DATE: 04.07.2015
TO: ProTrak
FROM: Bill McDow
Transportation Planning

■ **WILMINGTON TIRE AND AUTO [TRC Plan Review]**

↻ Initial Review Note ↻

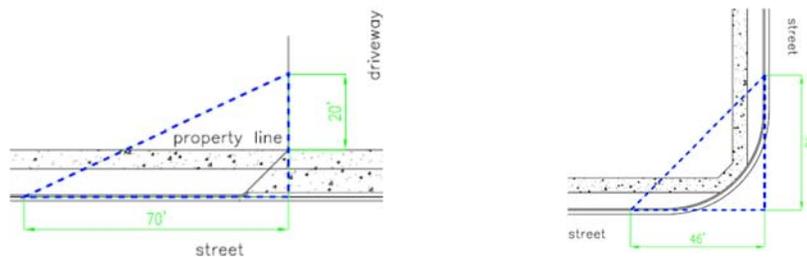
- ❖ Per the Institute of Transportation Engineers (ite) Trip Generation 9th Edition, 2012, Microtrans trip Generation Software; the estimated Trip Generation for the proposed **Retail Parts Sales + 2490 SF** (ite land use code 843) is 6 total driveway volume in the AM peak hours, 15 total driveway volume in the PM peak hours and 154 average weekday 2-way driveway volume. The estimated Trip Generation for the proposed **Repair Service + 5354 SF** (ite land use code 848) is 16 total driveway volume in the AM peak hours, 22 total driveway volume in the PM peak hours and 133 average weekday 2-way driveway volume. Total Driveway Volume is 22 in the AM Peak, 37 in the PM Peak and 287 average weekday 2-way volume.
- ❖ Based upon the proposed Land Usage and Intensity, a Traffic Impact Analysis (TIA) will not be required for this development.
